Great Marlborough Street, Manchester

Summary of Proposed Amendments to Consented Scheme

November 2023

Fire Strategy Approach

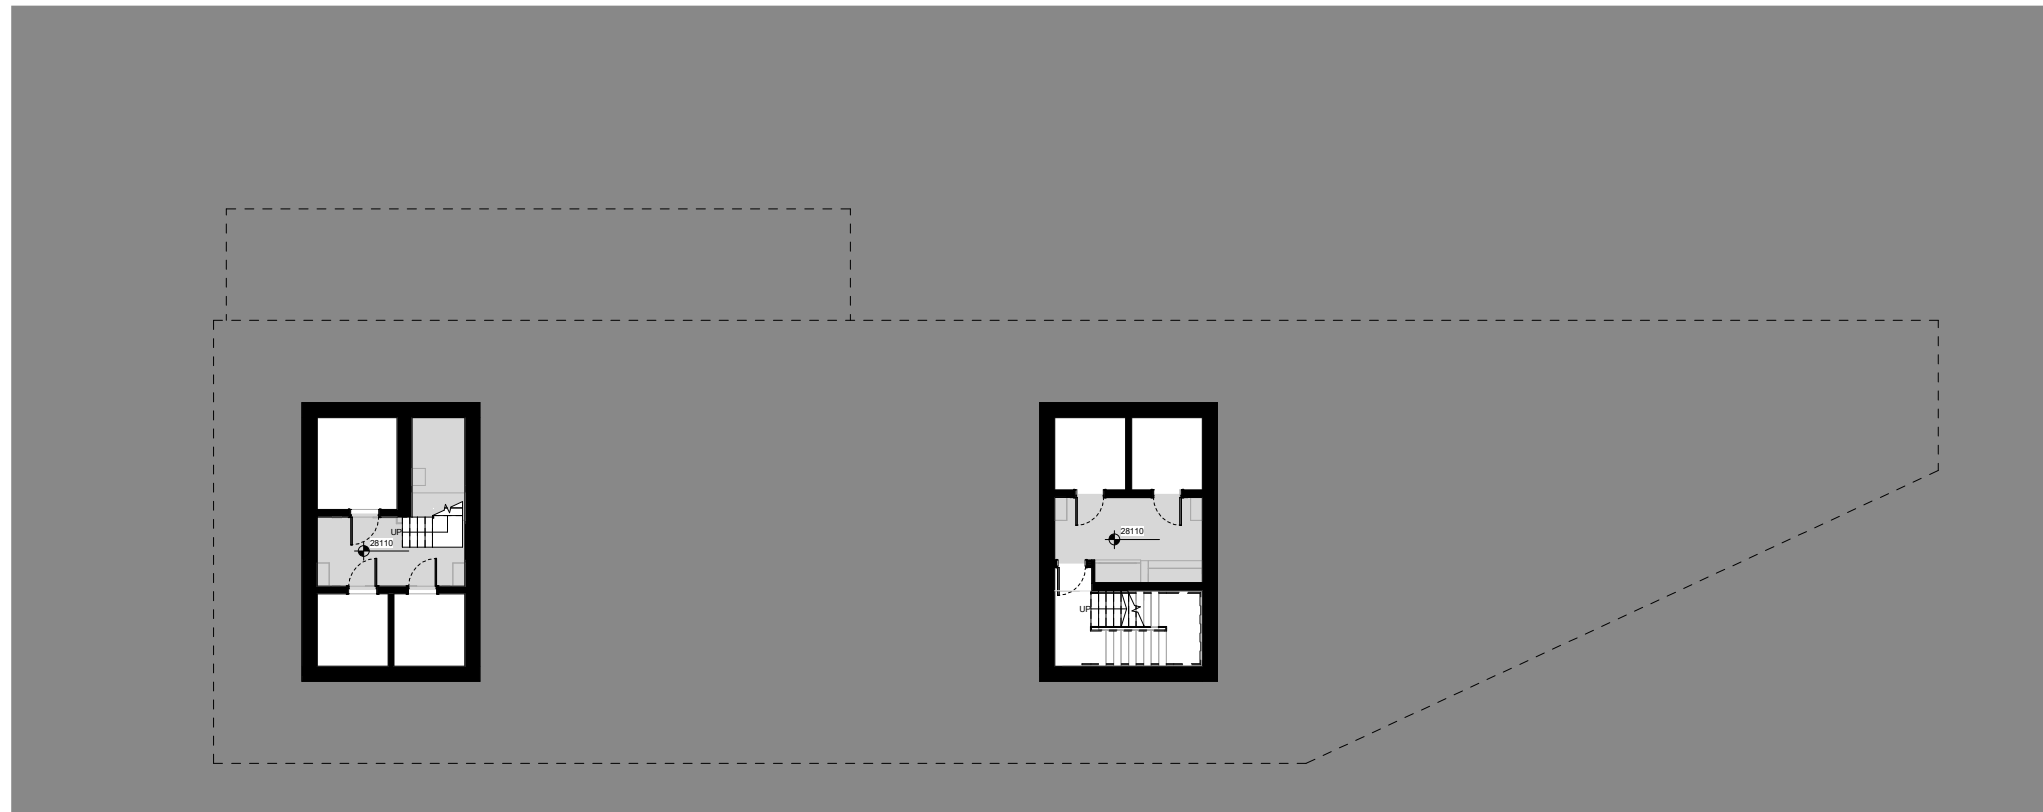
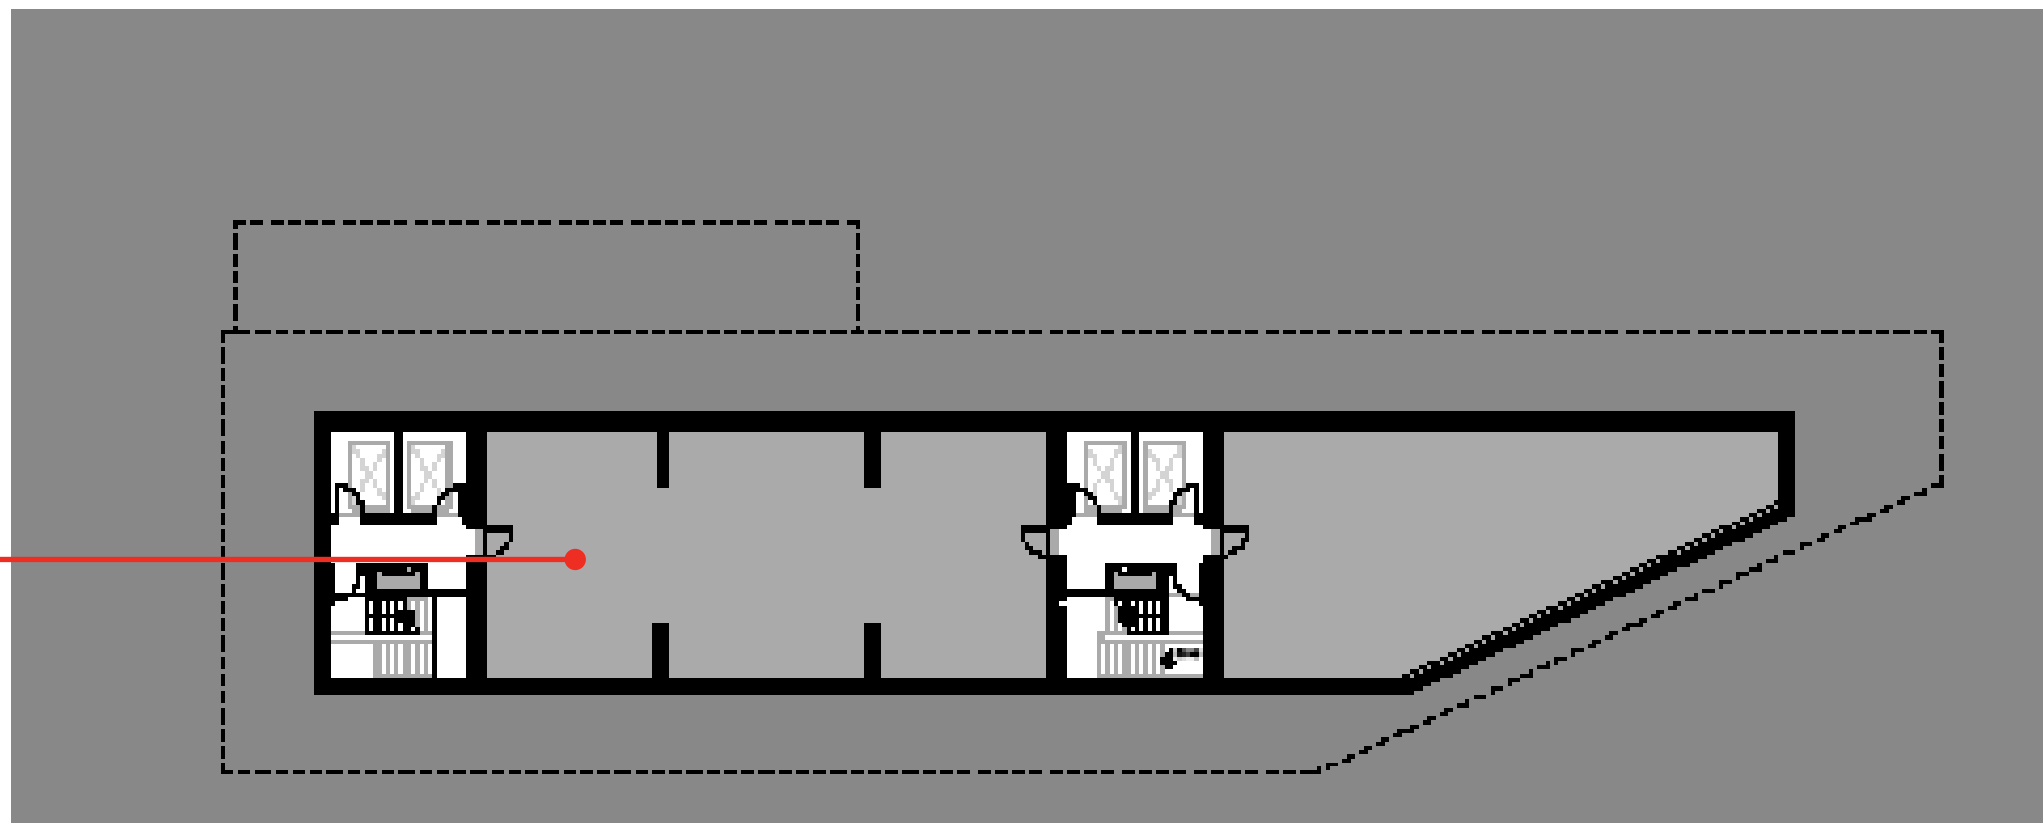
Provision of two separate cores, each with a ventilated stair, a firefighting lift, an evacuation lift, and inclusive of a ventilated lobby.

Basement Plan

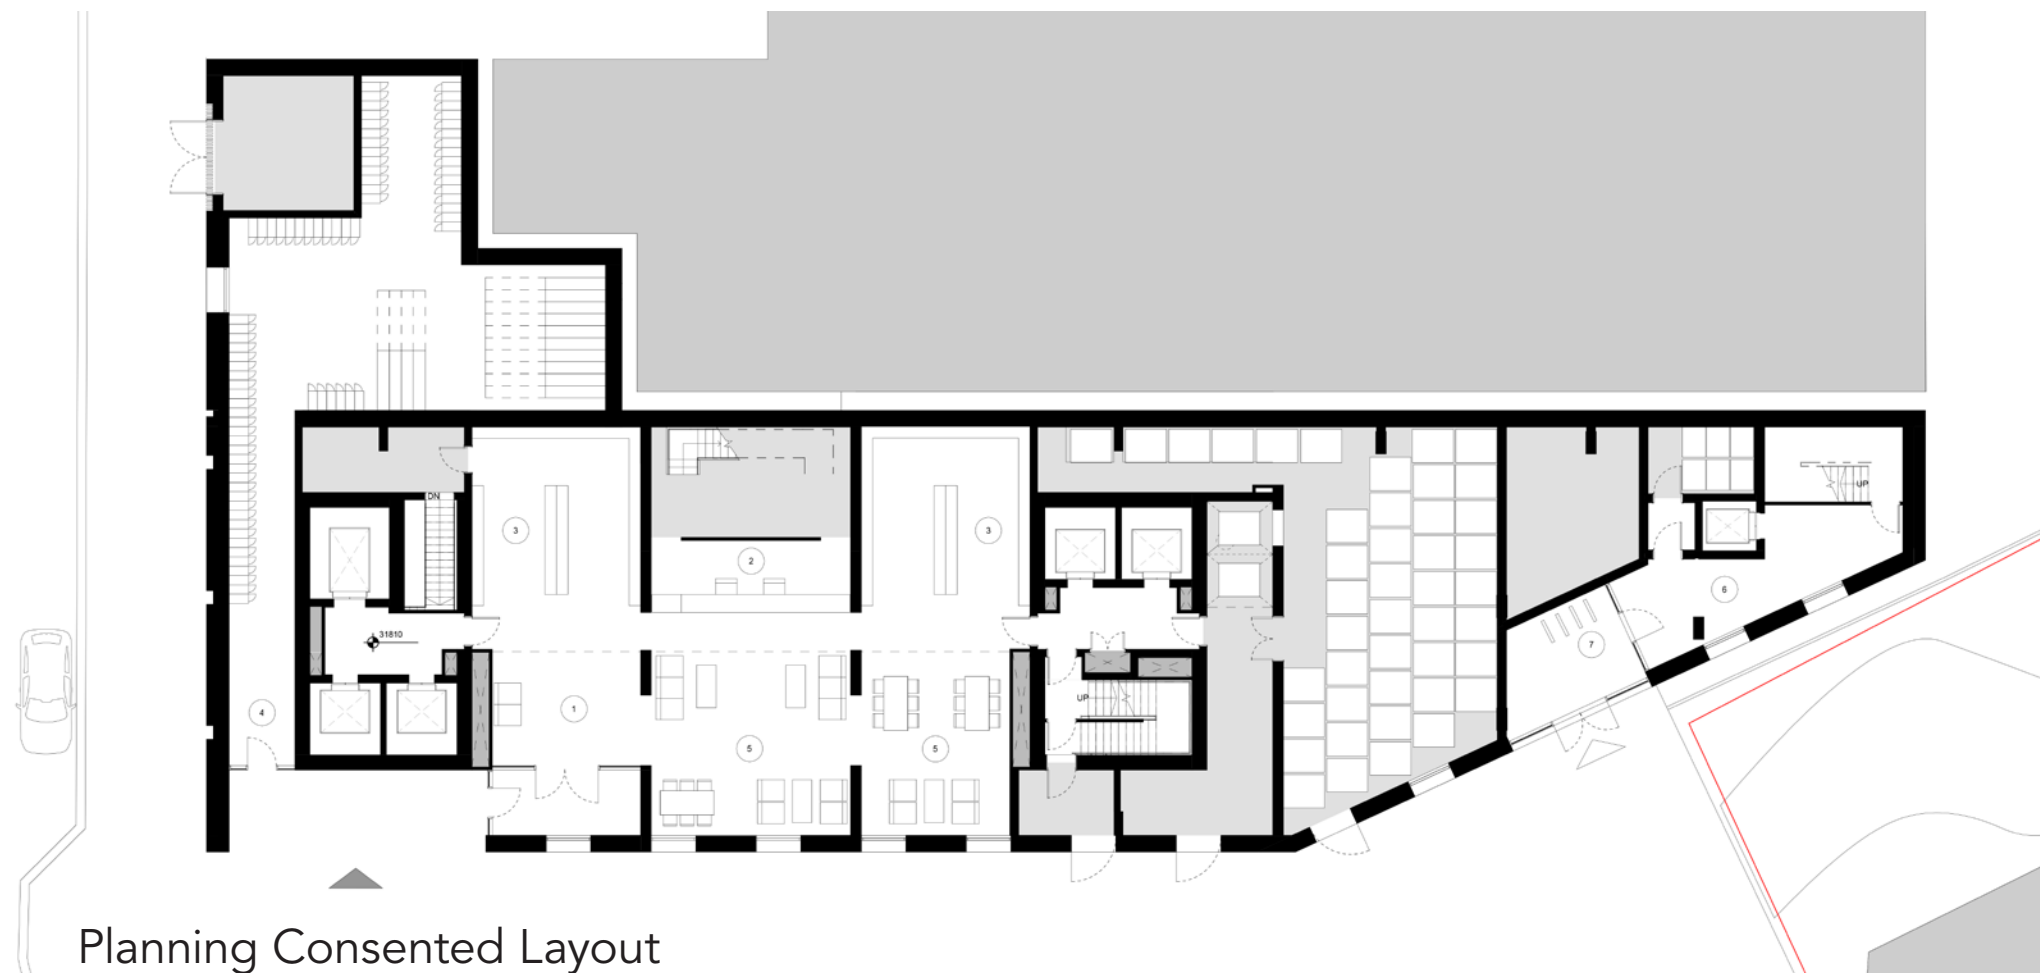
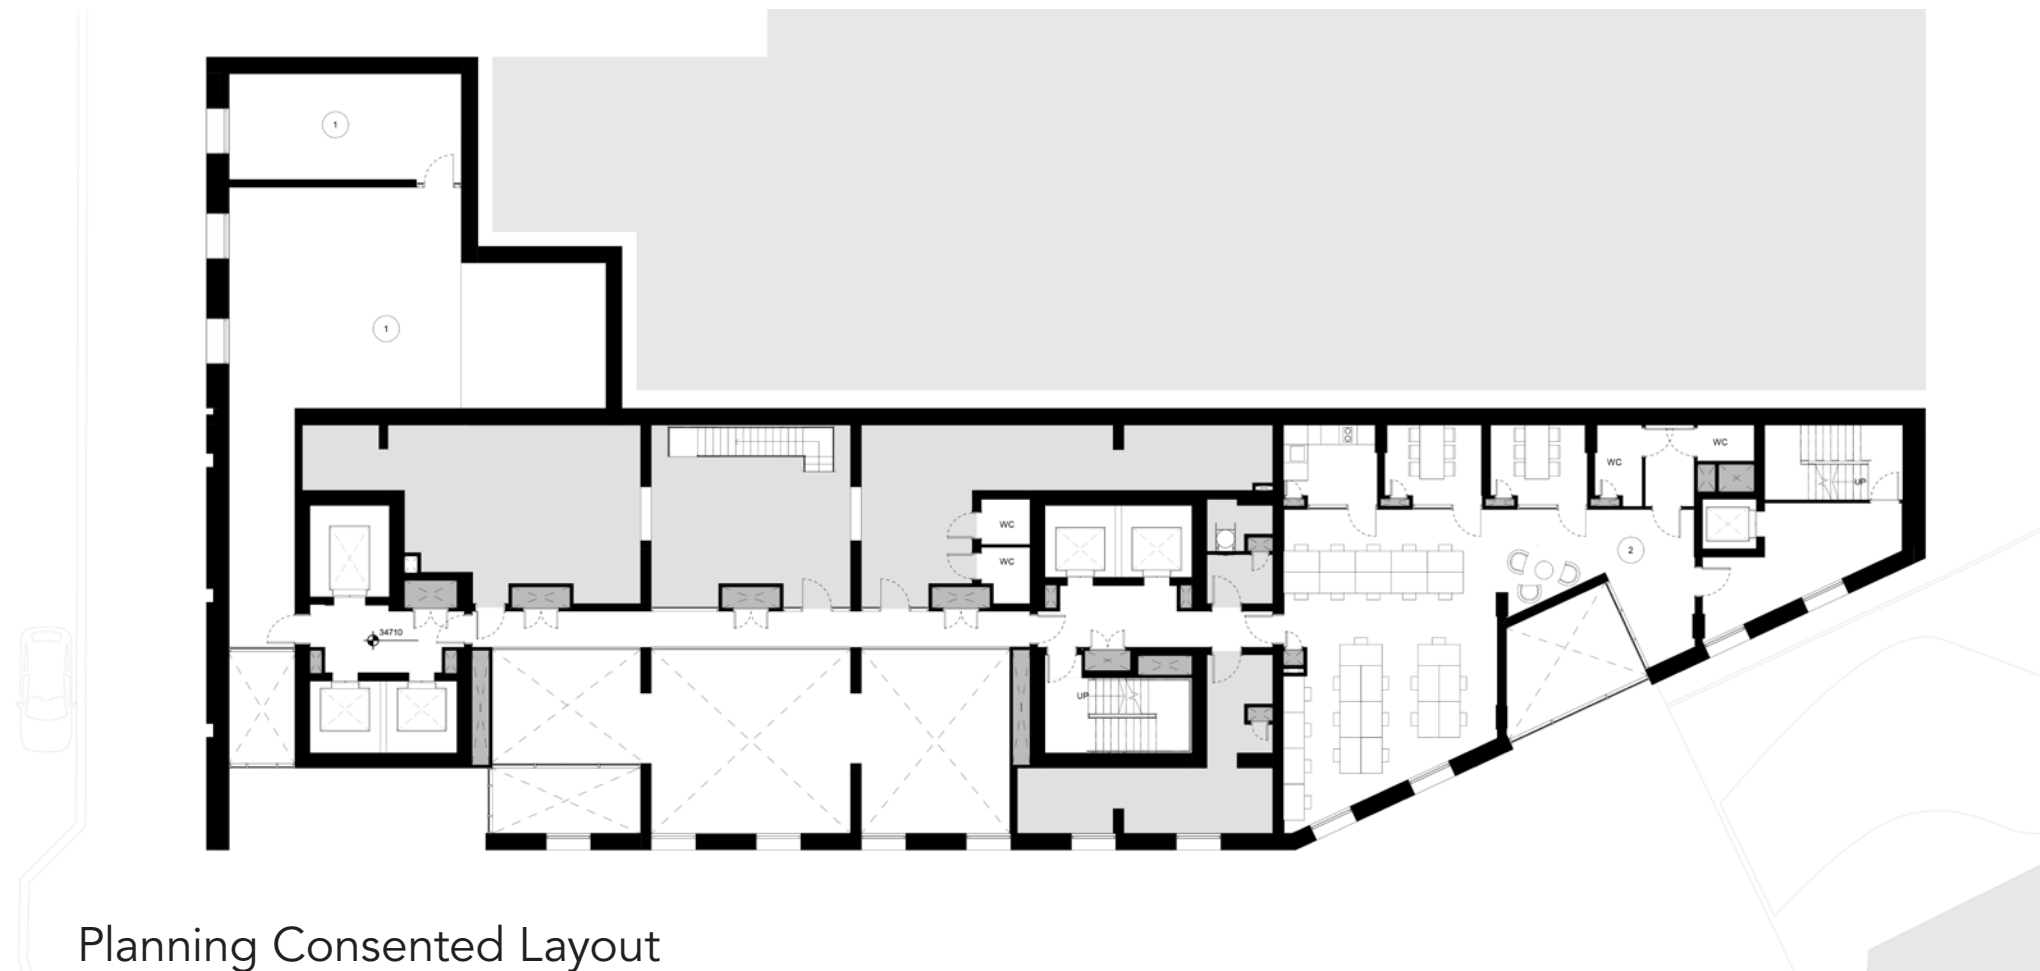
Additional
basement area to
accomodate
sprinkler and wet
riser tanks

Ground Floor Plan

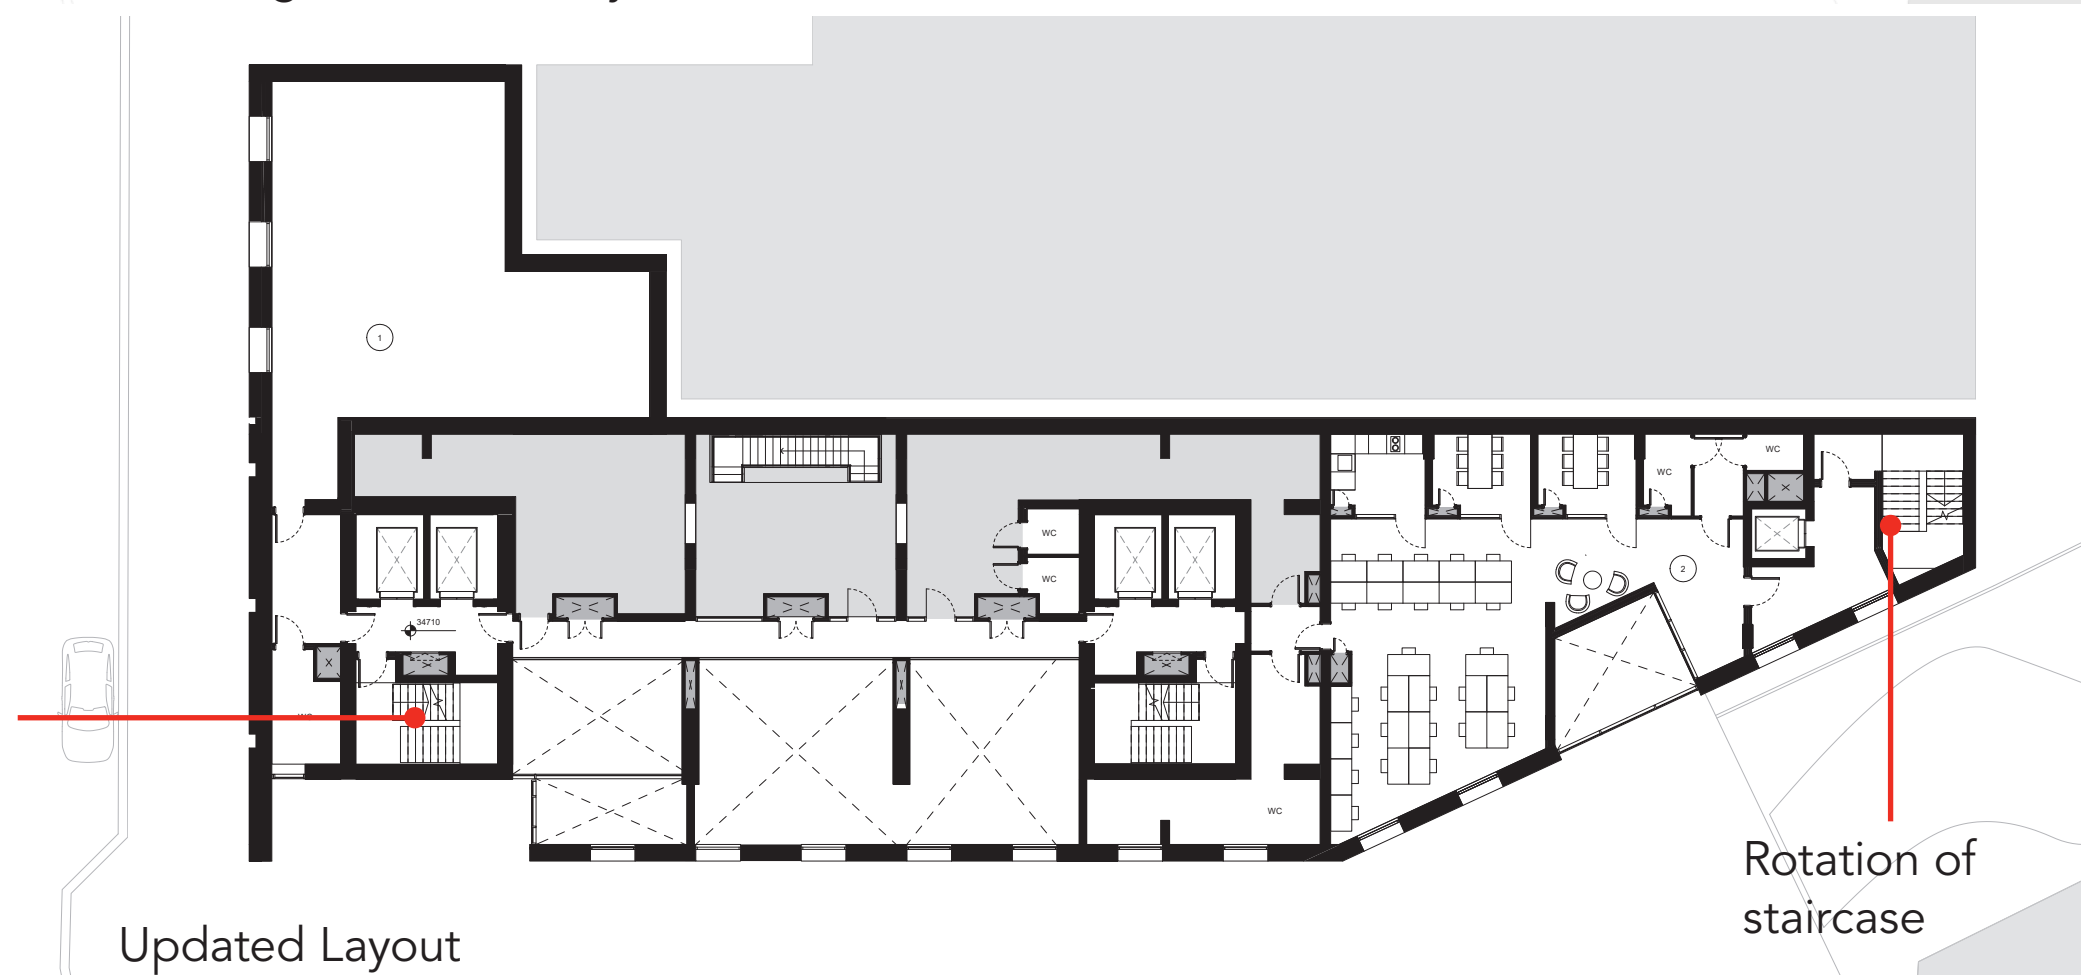
Reconfiguration
of cycle store
(same number of
spaces)

Minor
amendments
associated with
provision of
second staircase
and BS9991
requirements

Reconfiguration
of escape routes

Rotation of
staircase
